ADDENDUM NO. 3

Williams Brice Stadium Plaza Site Upgrades – Construction

State Project No. H27-6104-MJ-B

1 ROOF PLAN
 A110 1/8" = 1'-0"

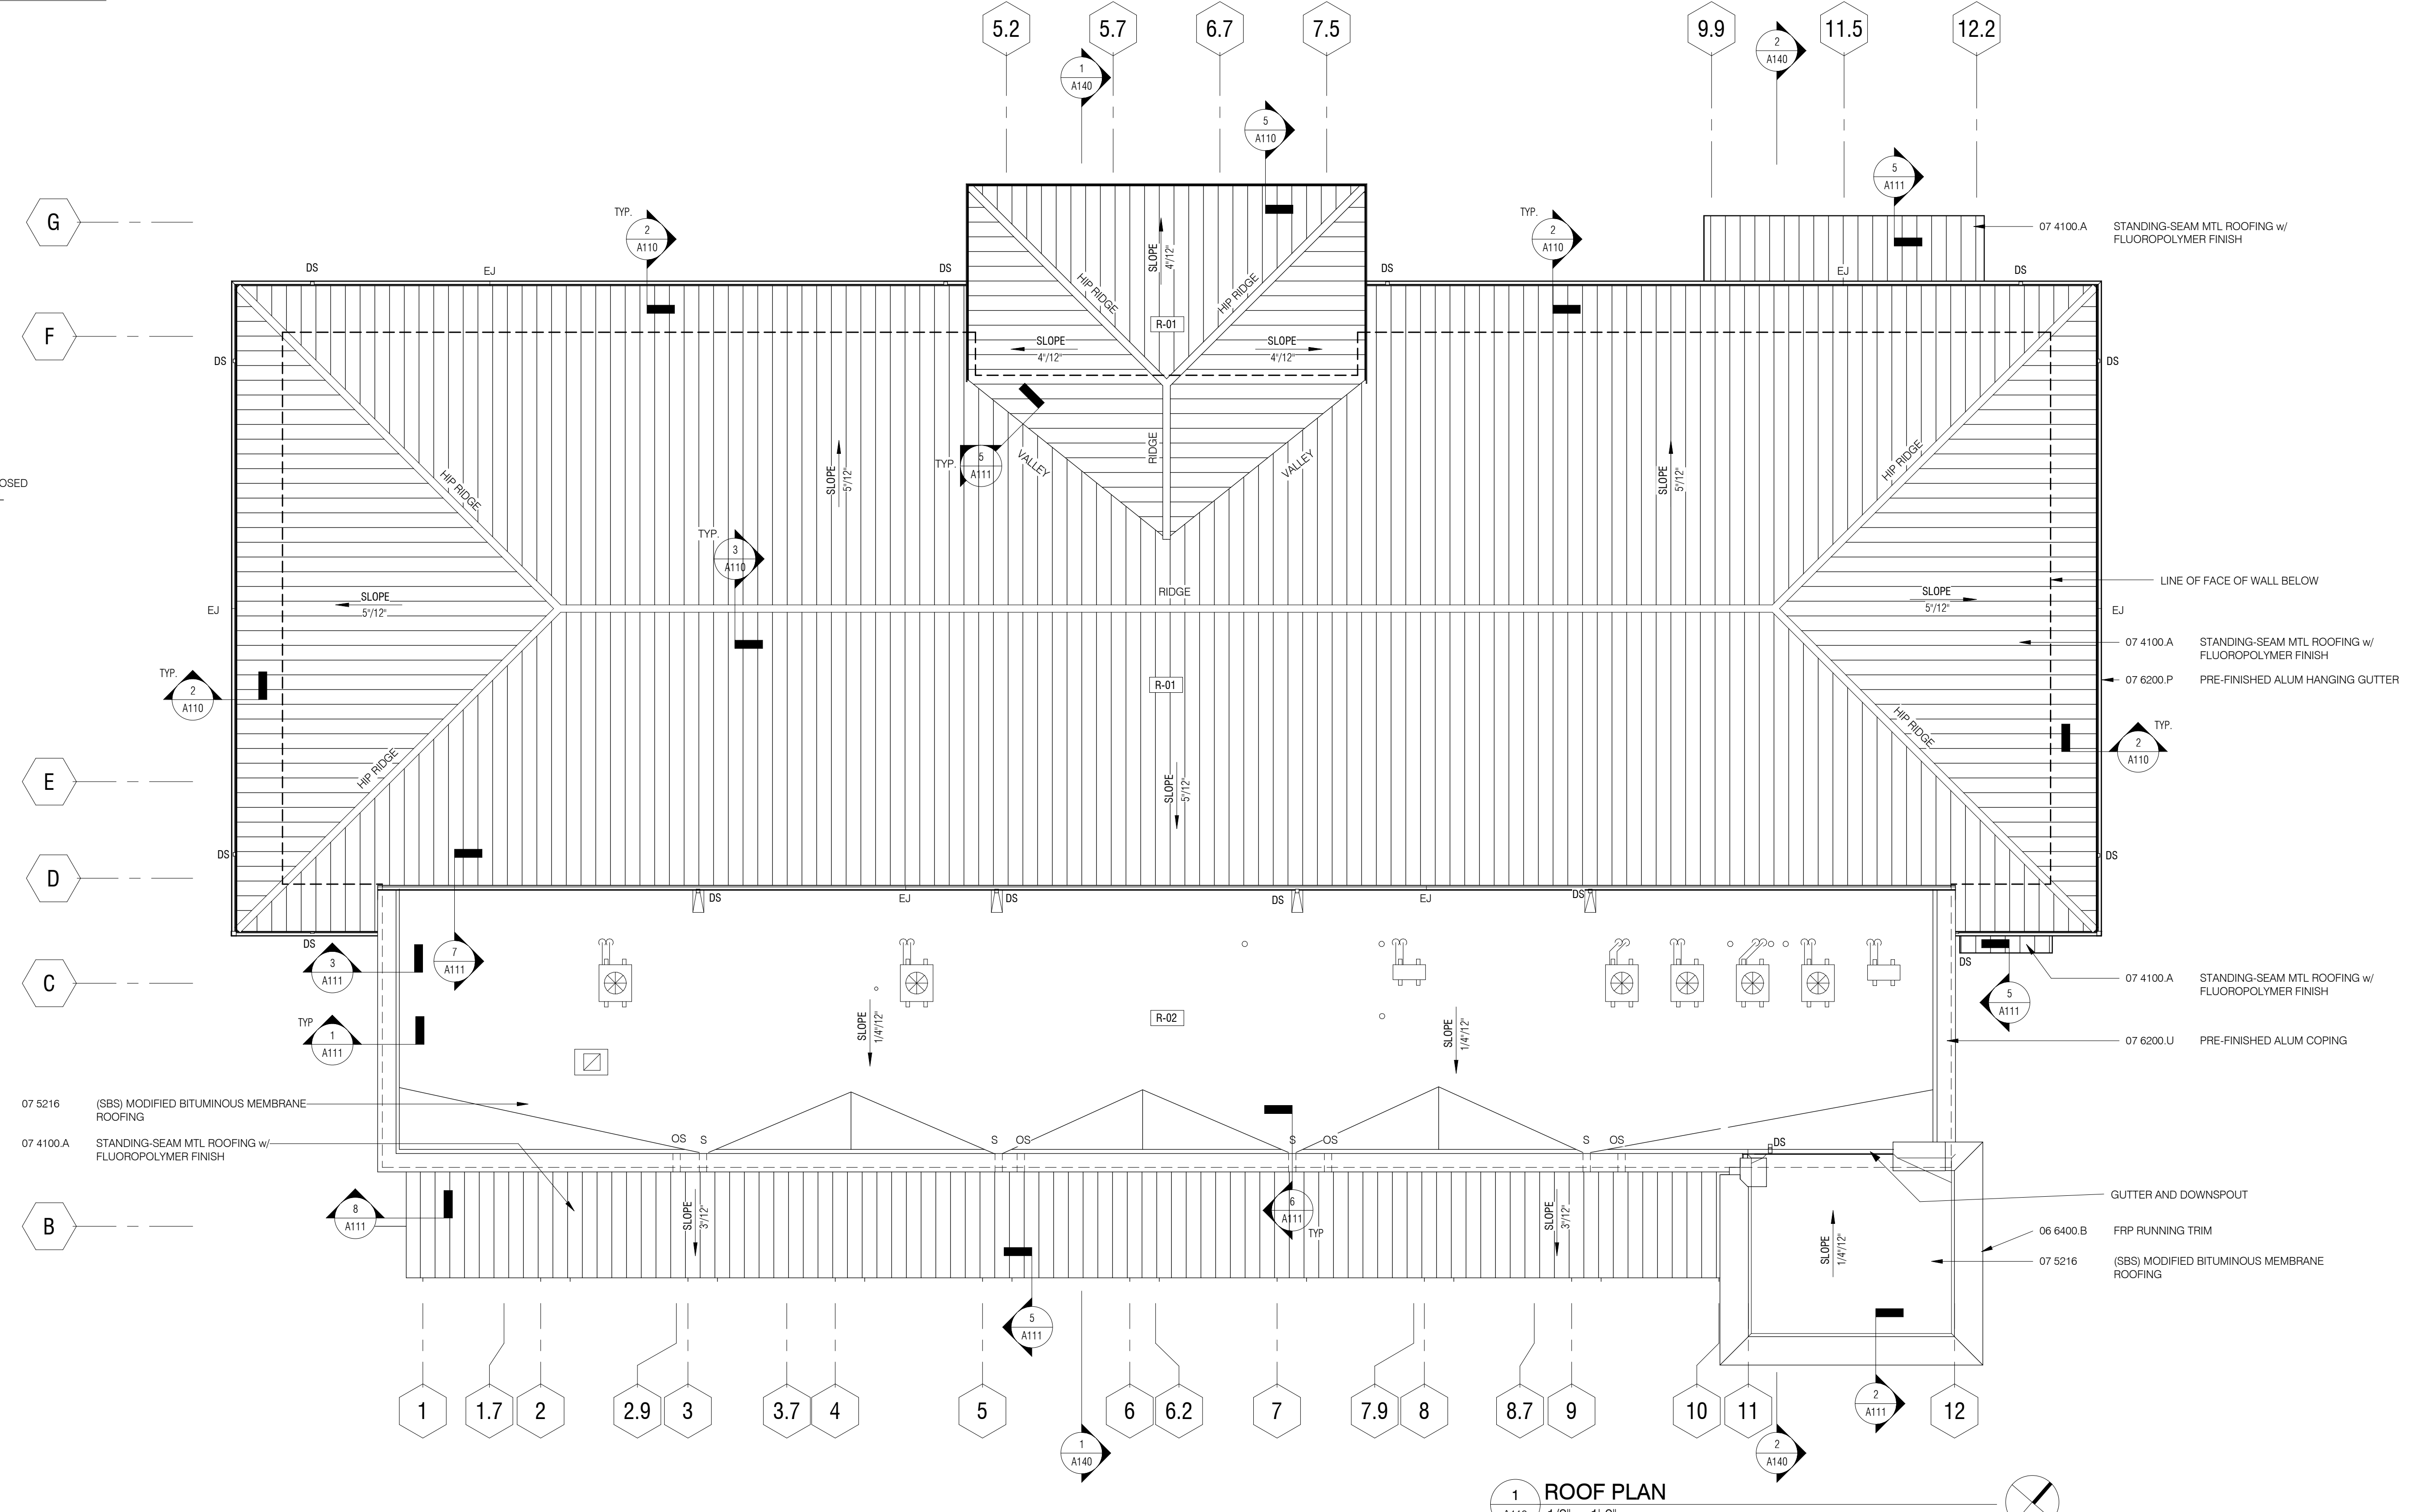
2. Drawing **“Roof Plan & Details” A110**, modify the typical roof details for the new R-value per the attached revised drawings.
3. Drawing **“FRP & Cast Stone Details” A161**, modify the FRP profiles per the attached revised drawings.
4. Contractors shall use plan sheet L200 and the legend contained therein for information pertaining to all concrete pavement locations and thicknesses. The Civil details and plans cover the asphalt pavements in the parking areas located just east of the Gameday building and on the south side of Key Road.
